DEVELOPMENT CONTROL COMMITTEE

ADDENDUM SHEET

4/02678/15/FUL & 4/02679/15/LBC – NEW BOUNDARY LINE TO DIVIDE THE EXISTING SITE & CREATE 3 NEW 4-BEDROOM LOW-ENERGY HOUSES TO THE LAND BEHIND LOXLEY FARM WITH ACCESS FROM ASTROPE LANE.

4/01658/16/FUL – CONVERSION OF EXISTING AGRICULTURAL BARN TO 2 SEMI DETACHED DWELLINGS

Updated Elevations – titles now corrected

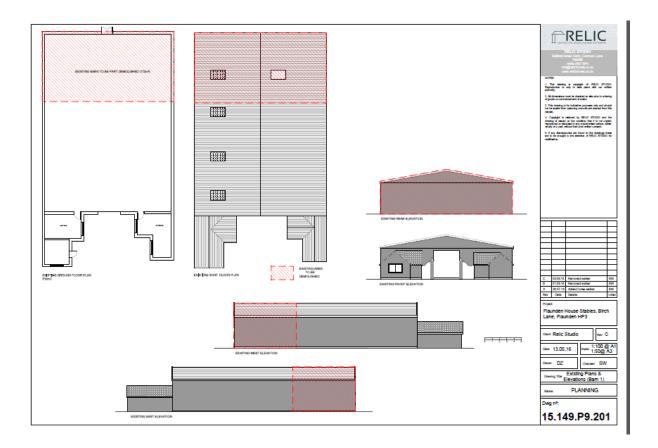
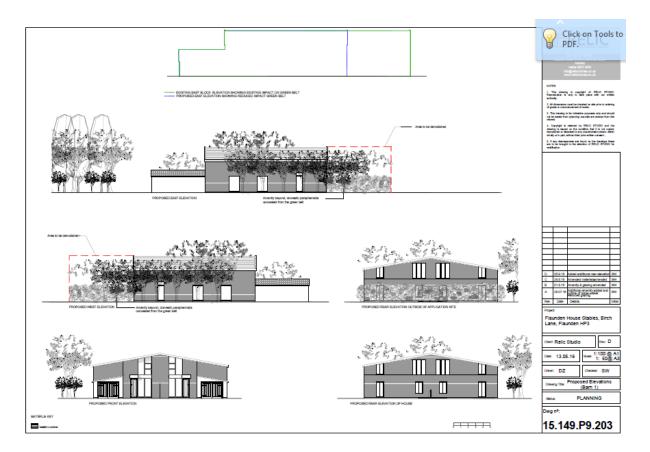
Amended plans showing that the horse exerciser is no longer part of the application.
